CALIFORNIA COASTAL COMMISSION

STAFF REPORT: REGULAR CALENDAR

APPLICATION NUMBER: 5-01-179

PROJECT DESCRIPTION: Demolition of an existing 5-unit apartment complex and construction of a new 4-unit condominium complex with a subterranean parking garage, hardscape and landscaping on a coastal blufftop lot. The project involves grading of approximately 796 cubic yards of material for garage excavation and site preparation. The project also involves approval of a Tentative Tract Map for the creation of condominiums.

PLOT PLAN WITH BLUFF EDGE DELINEATIONS

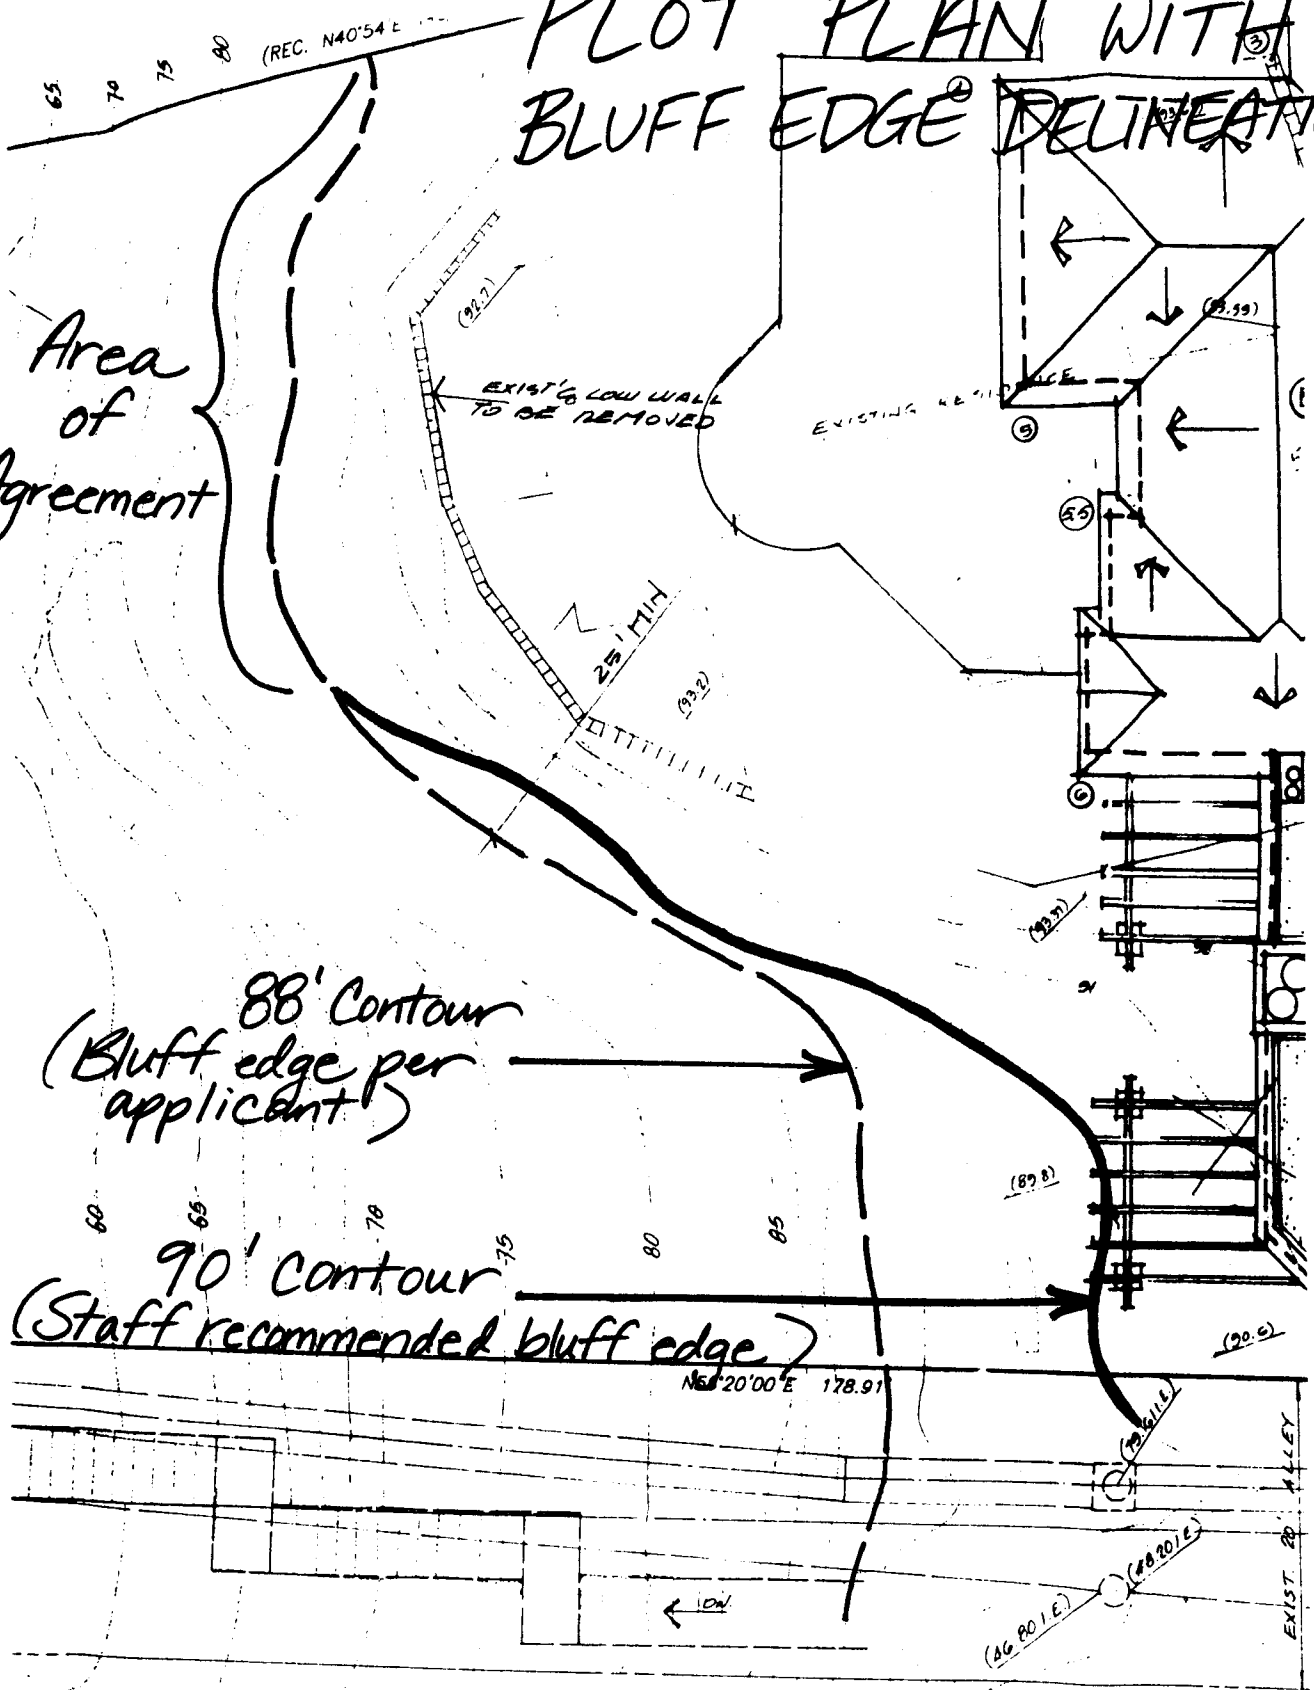
While the plans submitted show all new development to be set back from the bluff edge in accordance with the requirements of the LUP, the bluff edge is improperly depicted on the project plans. As such, the structural and hardscape setbacks are improperly depicted. Whereas the applicant depicts the 88-foot contour as the edge of bluff along the southernmost (downcoast) portion of the site, the Commission's methodology places the bluff edge at approximately the 90-foot contour. Using the 90-foot contour to establish the minimum bluff setback, a portion of the proposed structure encroaches approximately 10 feet into the required 25-foot setback and the proposed concrete patio encroaches approximately 4 feet into the typically applied 10-foot hardscape setback.

The Commission's staff geologist has reviewed the geotechnical information submitted and conducted a site visit. As stated in the Geotechnical Review Memorandum to district staff (Exhibit 7), "*identification of the 90-foot contour as the bluff edge approximates the topographic break in slope that occurs in the artificial fill material overlying the natural bluff edge. Although this topographic break does not represent a natural bluff edge, the 25-foot setback from the natural bluff edge believed to lie below also will serve to protect the structure and any ancillary structures from instability due to slumping or raveling of the artificial fill, a process that is currently ongoing.*" The natural bluff edge is difficult to determine due to the extent of historical grading and "*appreciable amount of artificial fill,*" as described by the staff geologist. However, in the absence of additional information regarding the configuration of the terrace deposits beneath the fill, the Commission finds that the bluff edge is the prominent topographic break roughly coincident with the 90-foot contour.

Applying the Commission's criterion for determining the bluff edge, the southwestern corner of the proposed structure is sited approximately 15 feet from the bluff edge, with the patio located 4 feet from the bluff edge. The northwestern corner of the structure is sited 25 feet from the bluff edge. Therefore, the southwestern portion of the site will encroach into the 25-foot structural and 10-foot deck setback areas by 10 feet and 4 feet respectively. As discussed previously, the City of San Clemente LUP requires proposed development on blufftop lots to be set back at least 25 feet from the bluff edge, or set back in accordance with a stringline drawn between the nearest corners of adjacent structures on either side of the development. The Commission has typically imposed a minimum 25-foot setback on new blufftop developments in San Clemente and approved the LUP requirement as consistent with the policies in the Coastal Act. Application of the 25-foot setback from the 90-foot contour line in this instance will provide for greater protection from potential hazard resulting from bluff failure.
